**CONTRACT I-20-4517**

**ROADWAY AND BRIDGE RECONSTRUCTION  
TRI-STATE TOLLWAY (I-294)**

**ADDENDUM NO. 2  
TO  
CONTRACT REQUIREMENTS  
FOR CONTRACT I-20-4517  
ILLINOIS STATE TOLL HIGHWAY AUTHORITY**

**Date: 7/28/2020**

CONTRACT NO. I-20-4517  
 ROADWAY PROFILE & SUPERELEVATION  
 NORTHBOUND  
 PRO-01  
 DRAWING NO.  
 199 OF 1762

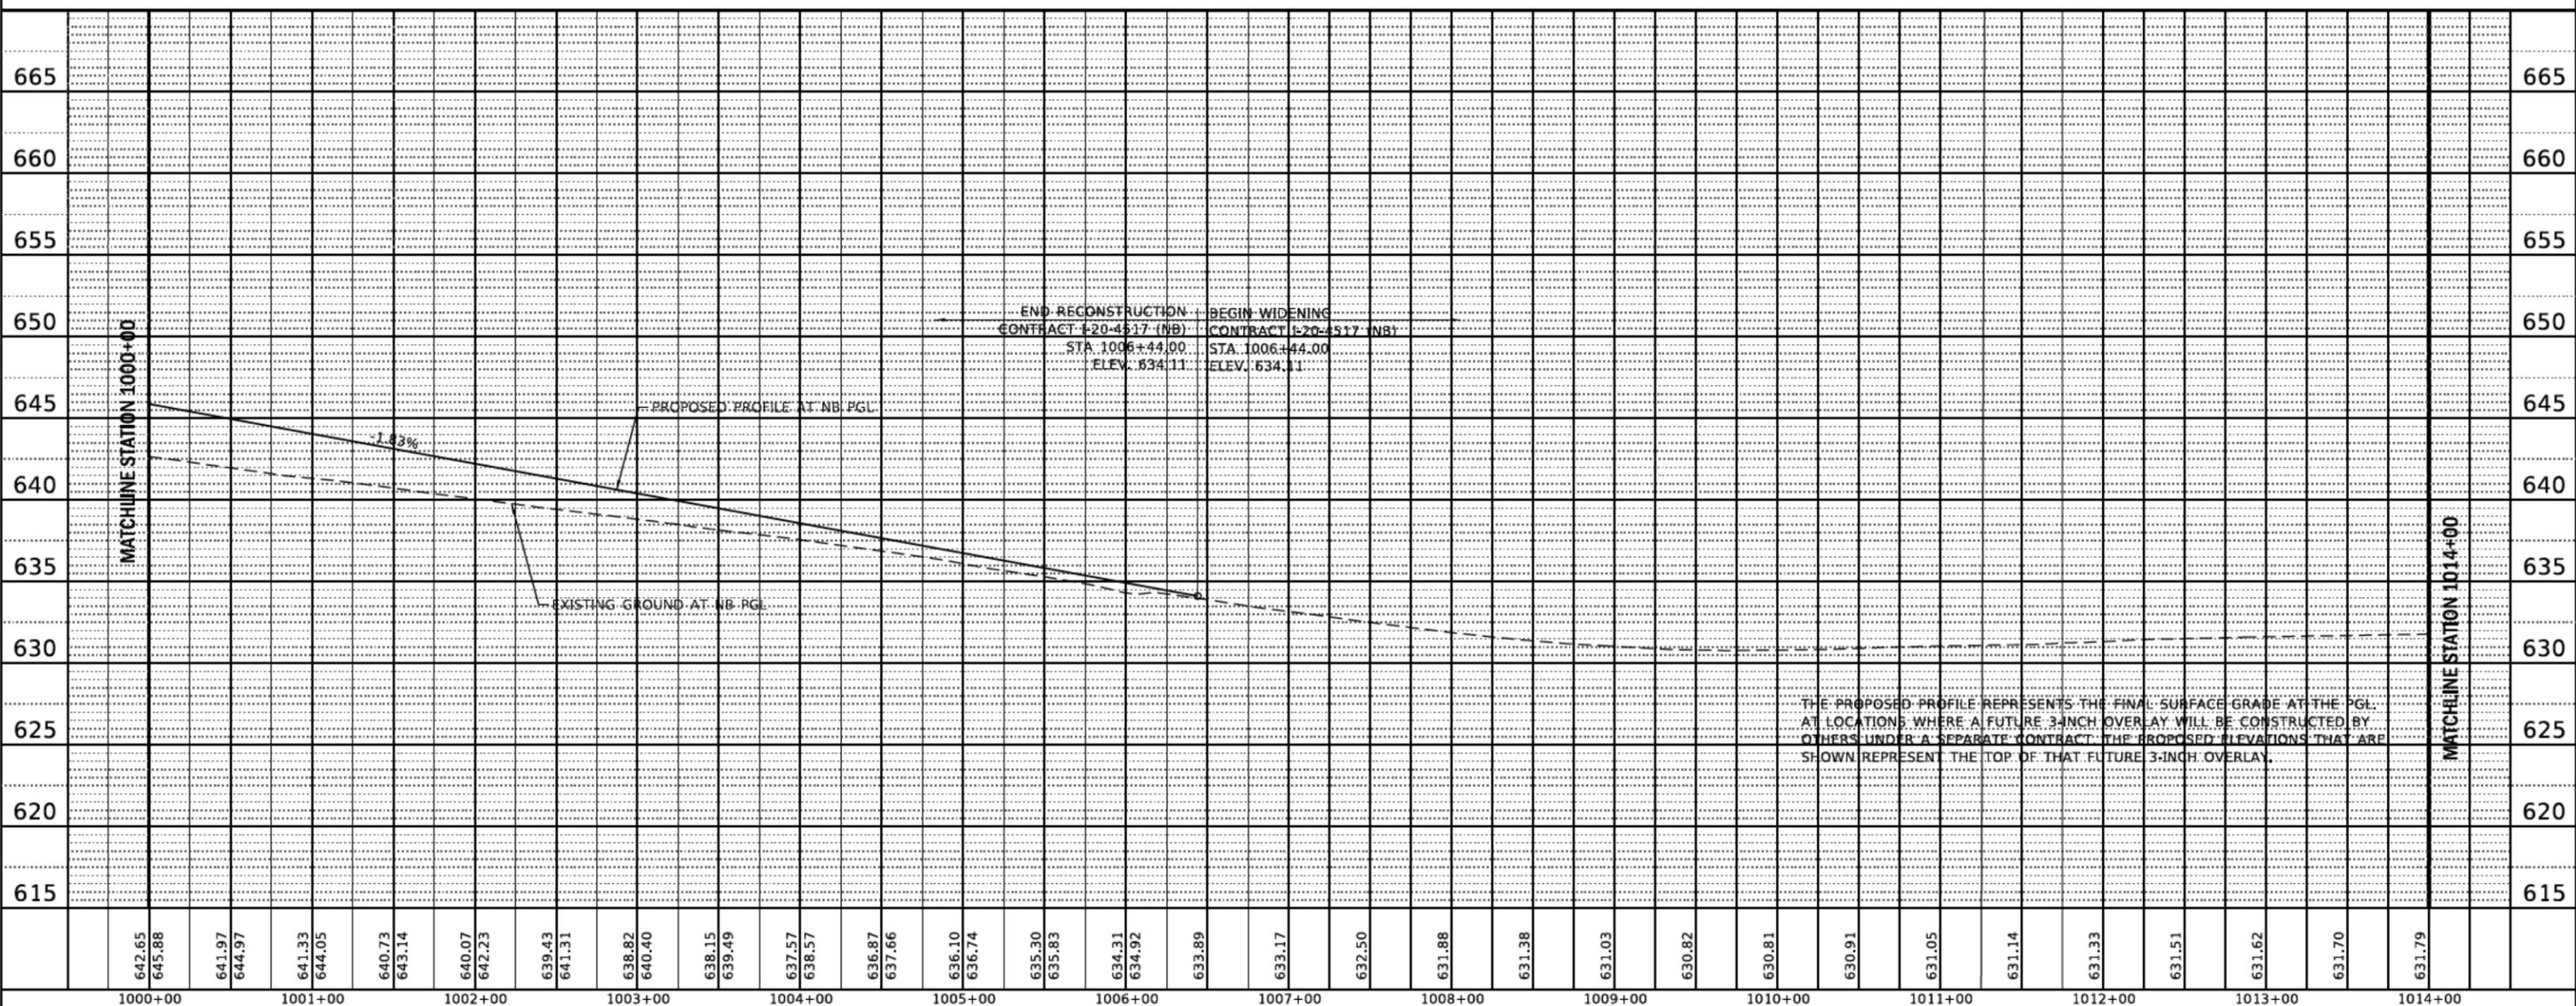
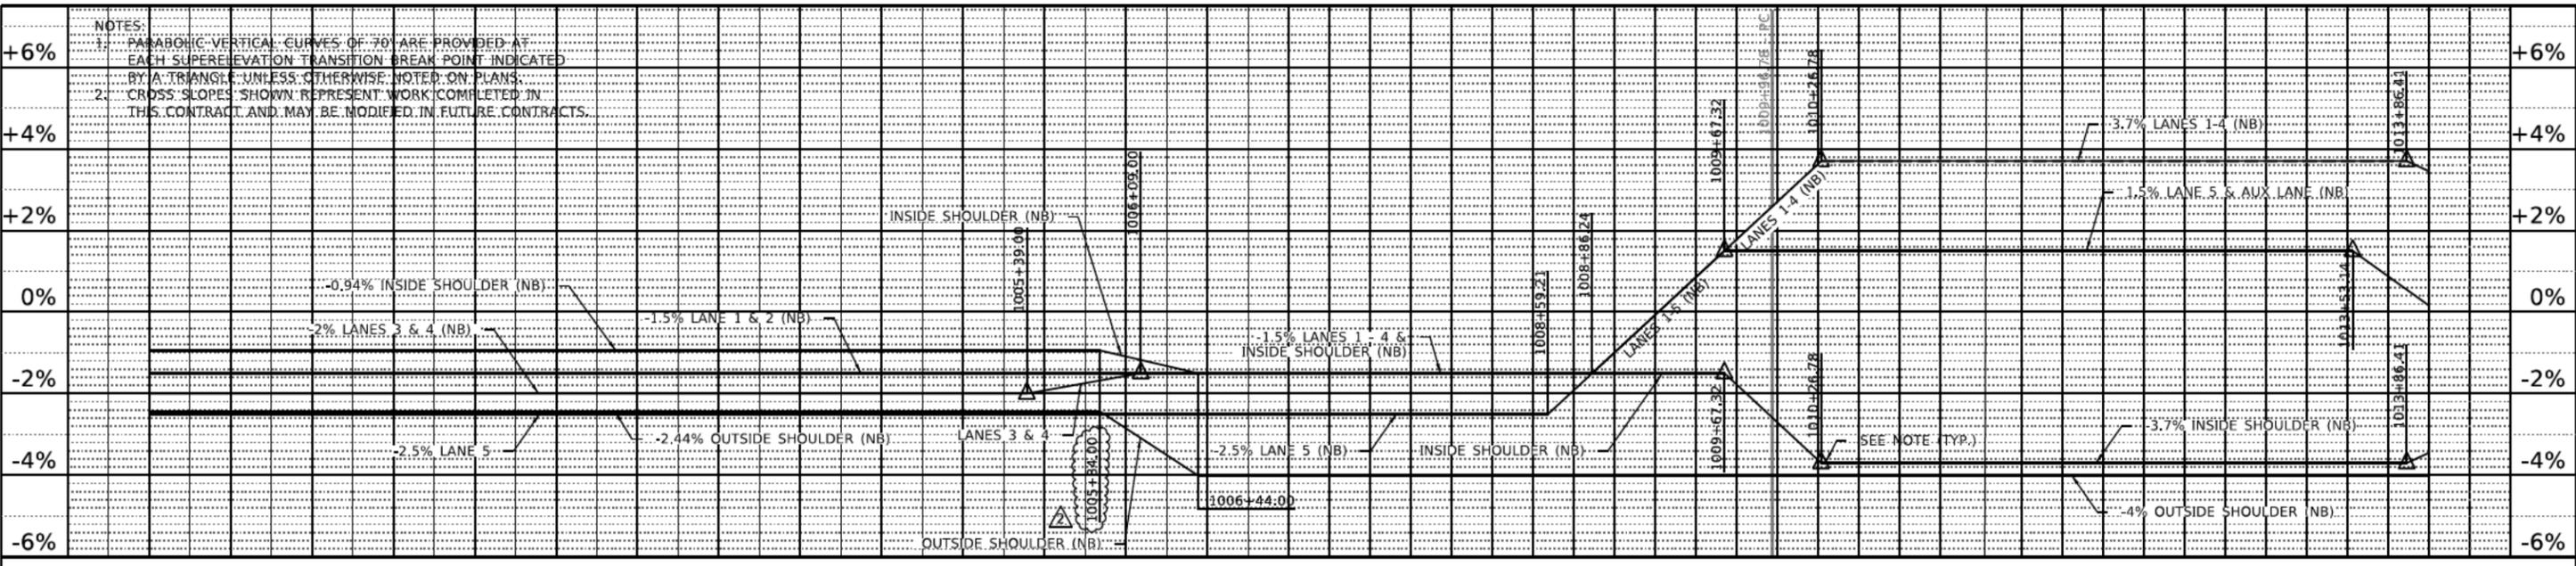
**Change #7** Contract Plans, Volume 1, Drawings 199, 200, 202, 204, 206, 207, 209, 213. Roadway Profile and Superelevation. These drawings contain the following revisions (attached):

- 7.1. Revised shoulder cross-slopes.
- 7.2. Added callouts indicating range of cross slopes for areas with variable cross slope.

ITS-12  
 DRAWING NO.  
 513 OF 1762

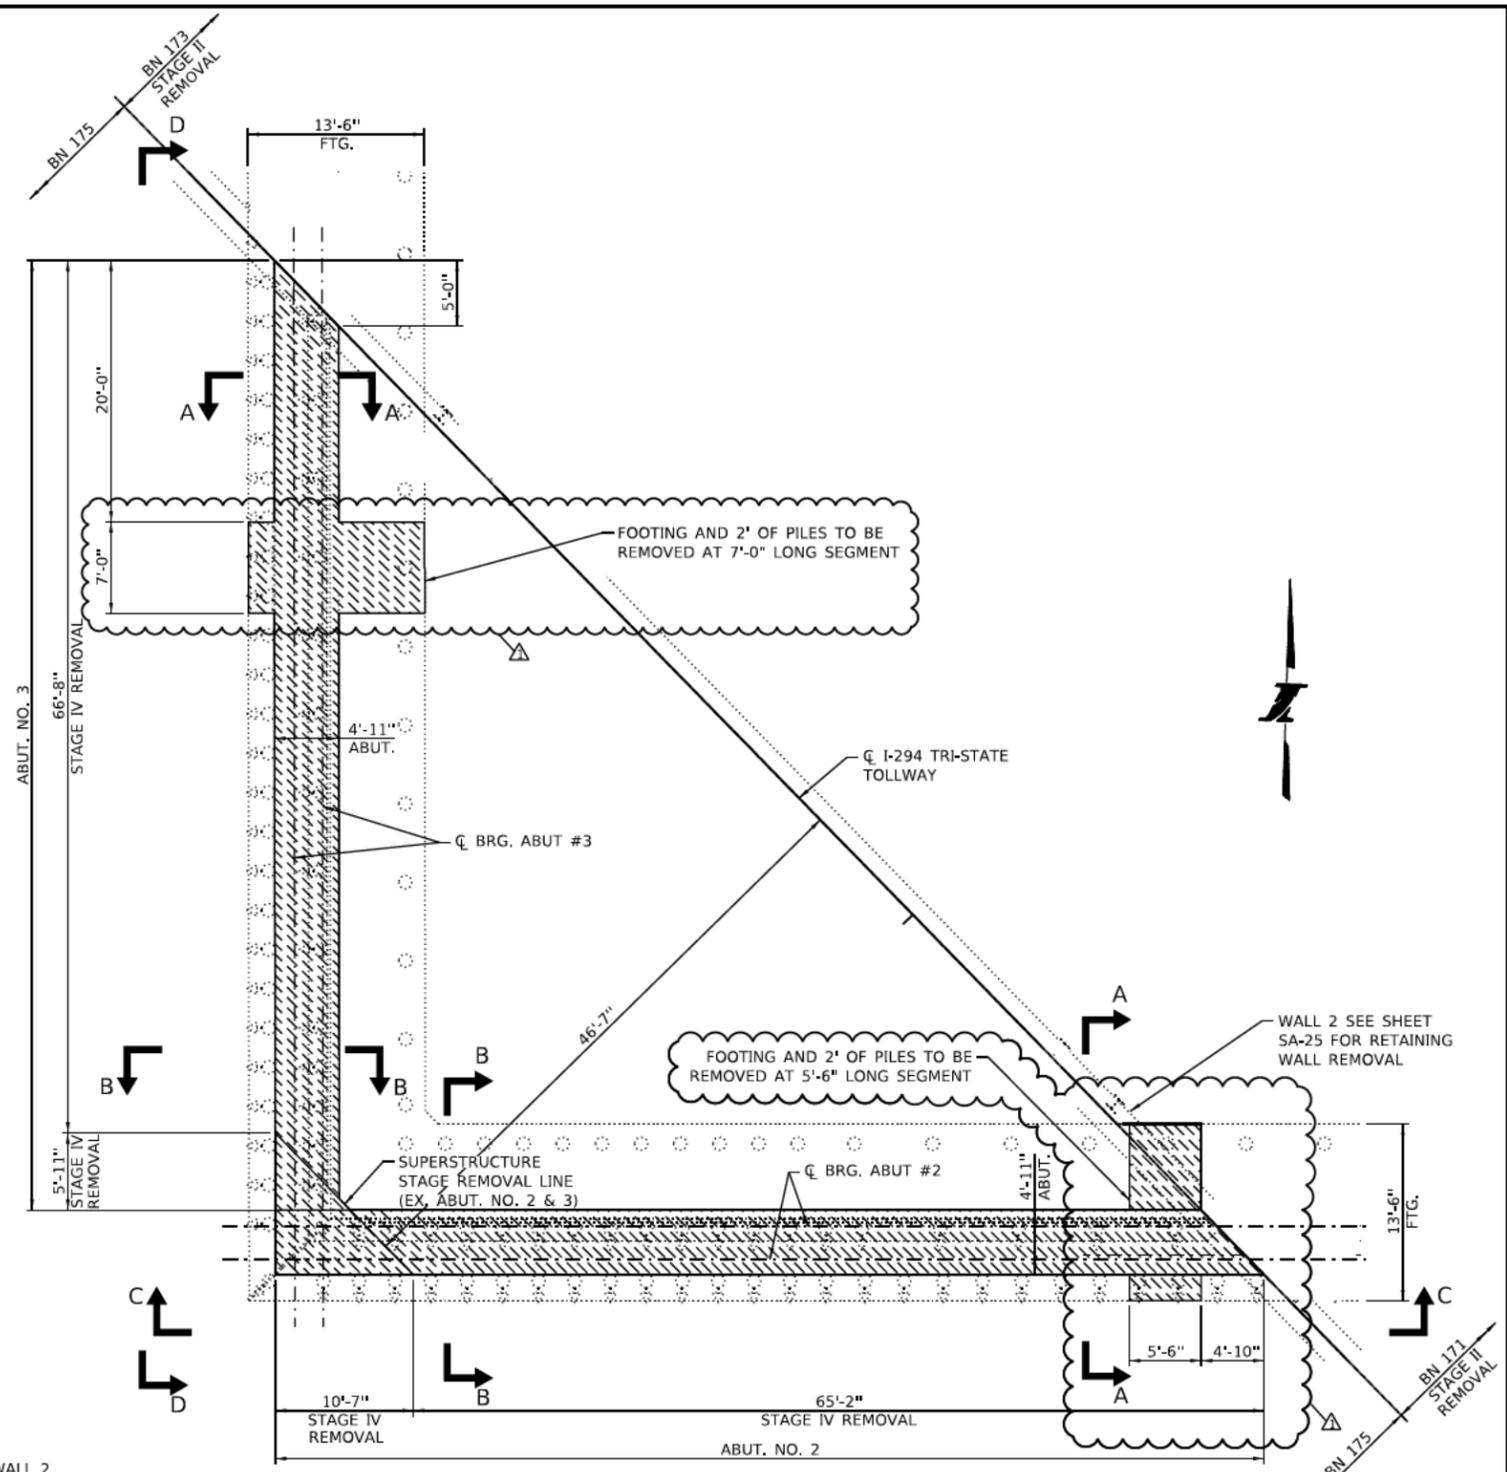
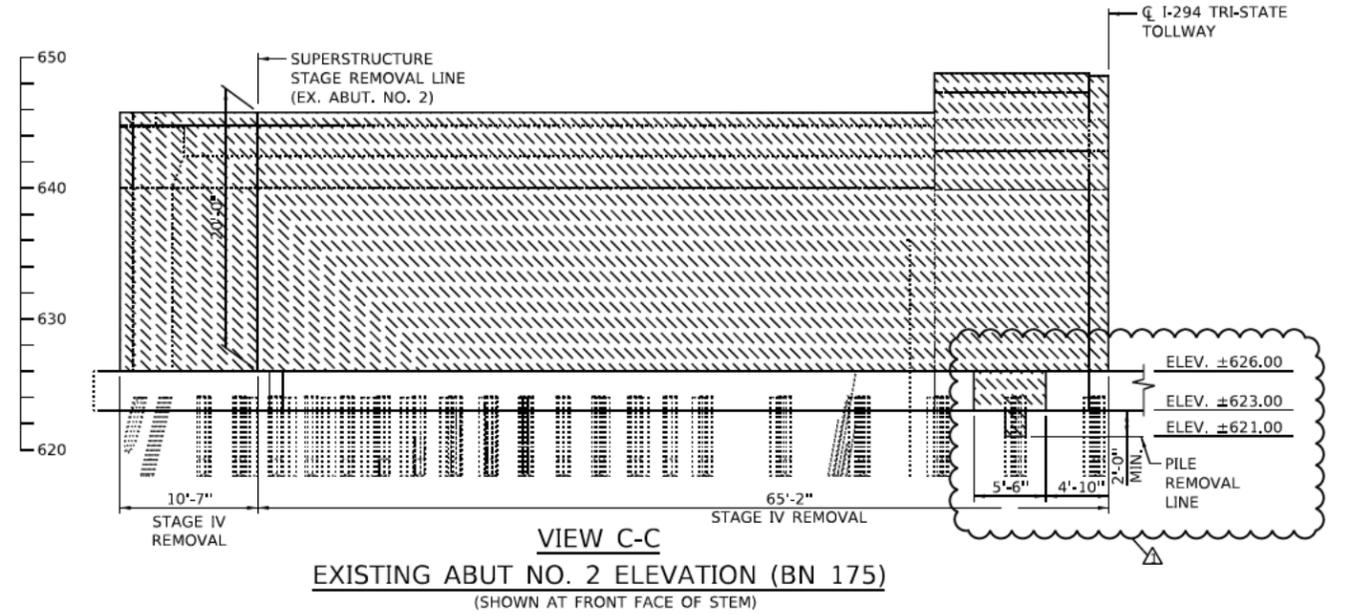
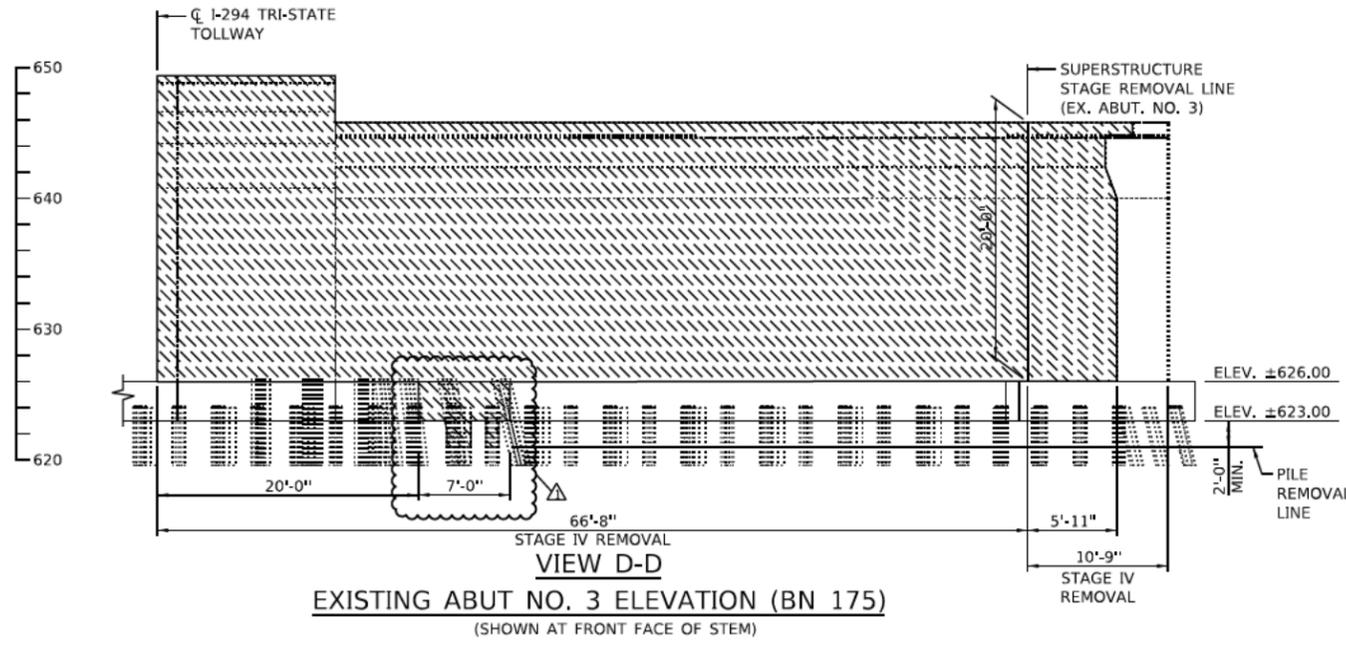
**Change #41** Contract Plans, Volume 2, Drawing 513. Proposed ITS Plans. This drawing contains the following revision (attached):

CCSCH-22  
 DRAWING NO.  
 1574 OF 1762

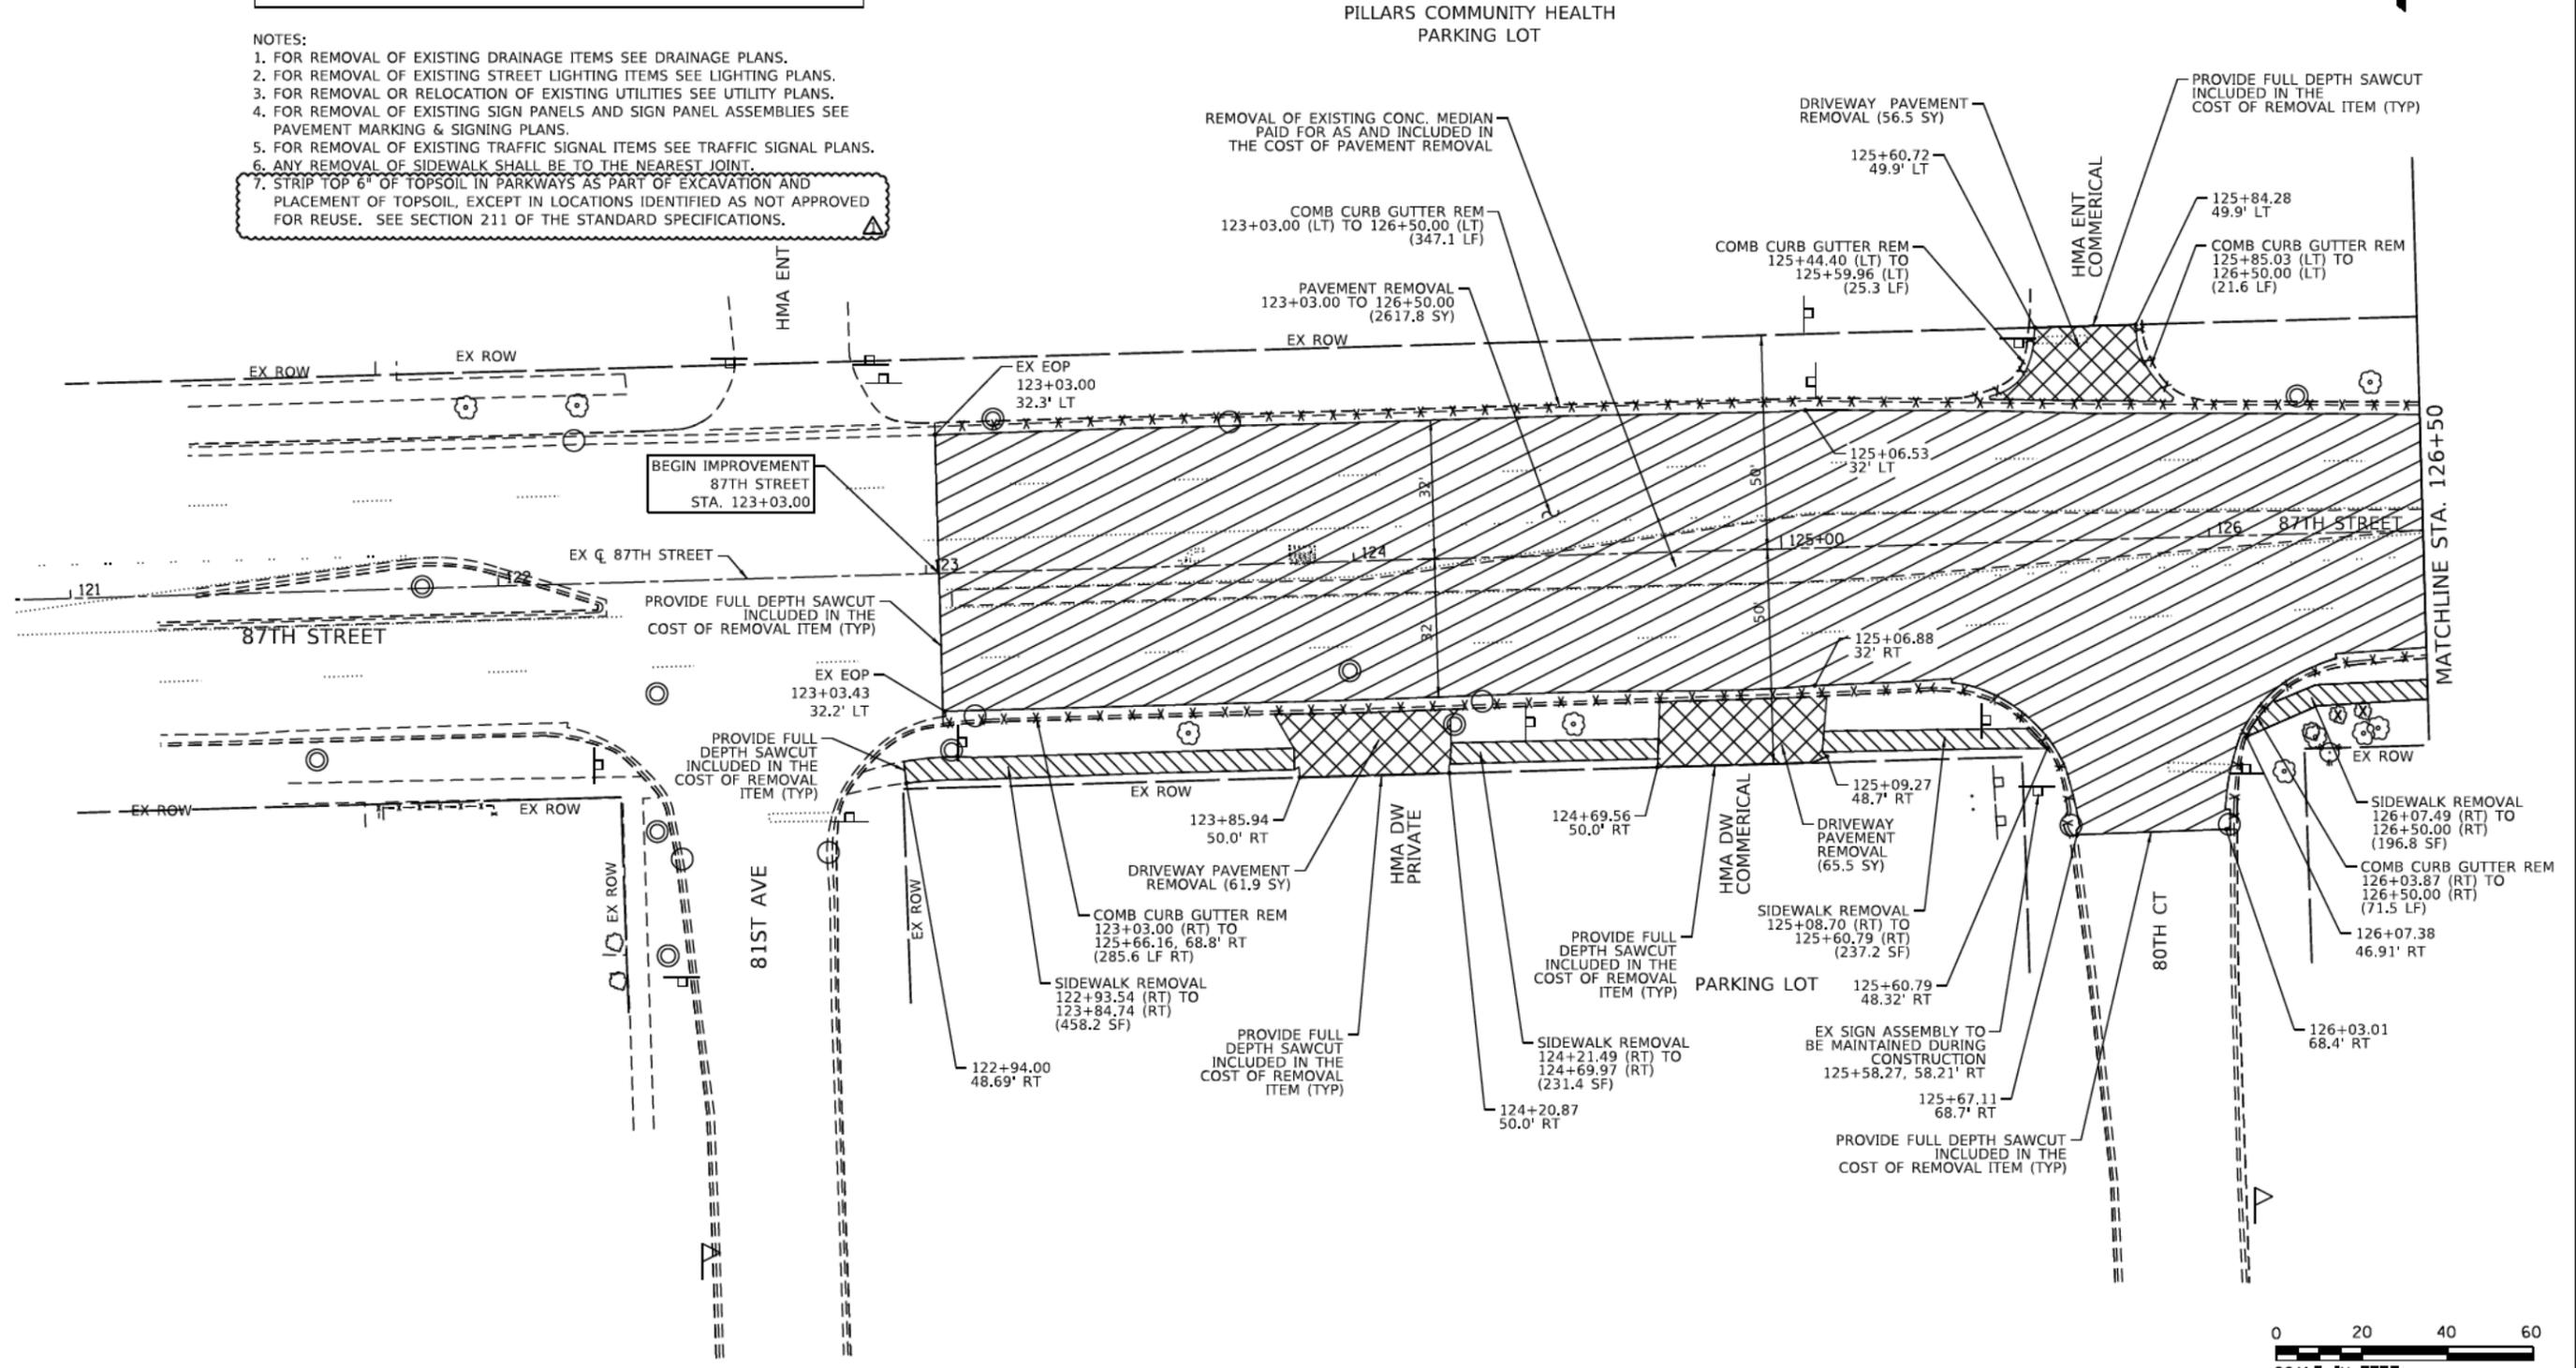
**Change #58** Contract Plans, Volume 7, Drawing 1574. Roberts Road and 87<sup>th</sup> Street Earthwork Schedule. This drawing contains the following revision (attached):
